Service Bulletin

Potential error message

"Active Fault, accelerator voltage low"

S/N affected: All CS3001 and CS4002 U-Deck drill rigs.

New connection location inside panel

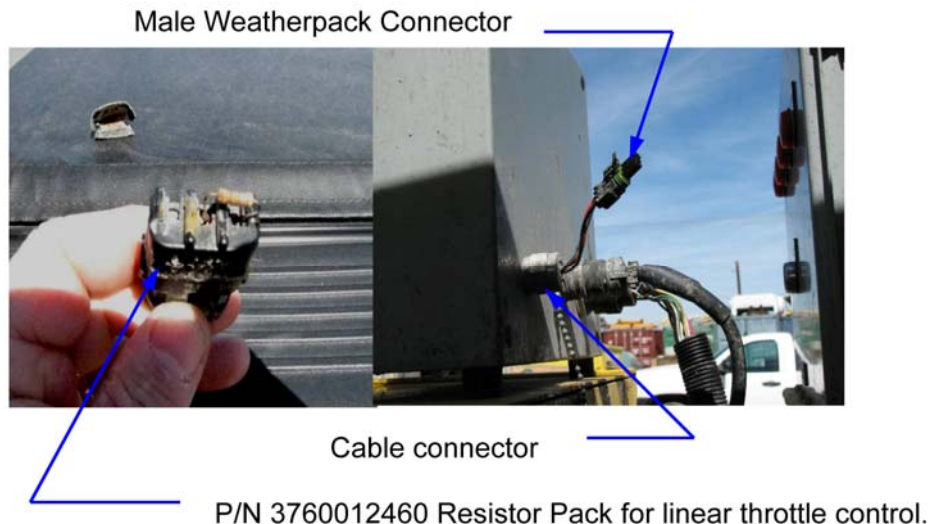
We have found recently that we have a 3 prong connector on the back of the panel. This connector is for a remote throttle but we do not use this option and therefore deadhead with a blind plug with two resistors in it. The seal on the end may fail and the resistors become corroded causing the fault code.

- Replace existing resistor pack with new
- Cut wires to male Weatherpack connector leaving enough wire to re-splice.
- Relocate Weatherpack connector & resistor pack inside Starter panel & splice wires (in location shown below)
- Place a generous bead of waterproof sealant in the opening of the external cable connector to form a watertight seal.
